STAFF RECOMMENDATION

NCPC File No. 6894

FORT BELVOIR, MUSEUM SUPPORT BUILDING

Fort Belvoir, Fairfax County, Virginia

MUSEUM SUPPORT BUILDING PRELIMINARY SITE PLAN

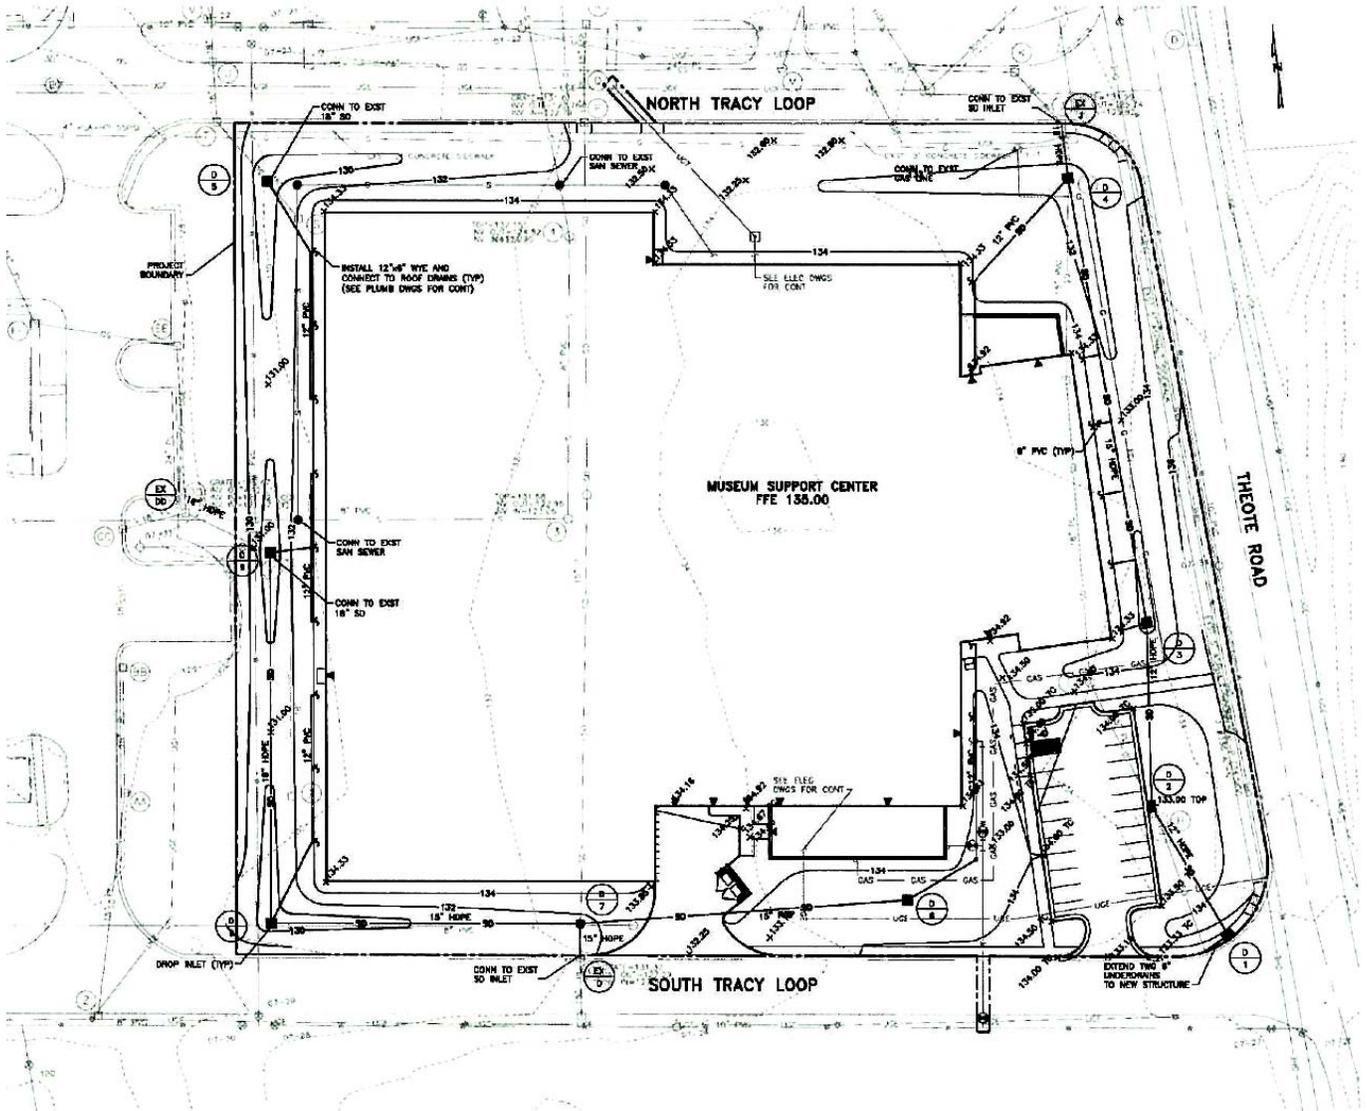
The building's preliminary site design indicates the perimeter use of trees to mask the large building facades. The use of a natural rain garden at the north end of the site will allow a lower scale buffer area of plantings that will also help control stormwater drainage from the site.

The Army has achieved a well integrated plan of development of the Museum Support Building that compliments features of its proposed location by relating balanced proportions of the building to the existing bounding roadways and maintaining the present drainage patterns of the industrial site. Additionally, by adding landscaping to the currently barren site, the proposal re-introduces trees adjacent to Theote Road and reduces the prominence of the planned structure.

Recommends that the Army provide, in its final project submission for the Museum Support Building, documented actions that will be achieved by the project to support the transportation management plan (TMP) developed for Fort Belvoir master plan. Specified Museum Support operations should be noted that meet the alternative transportation programs of the master plan TMP.
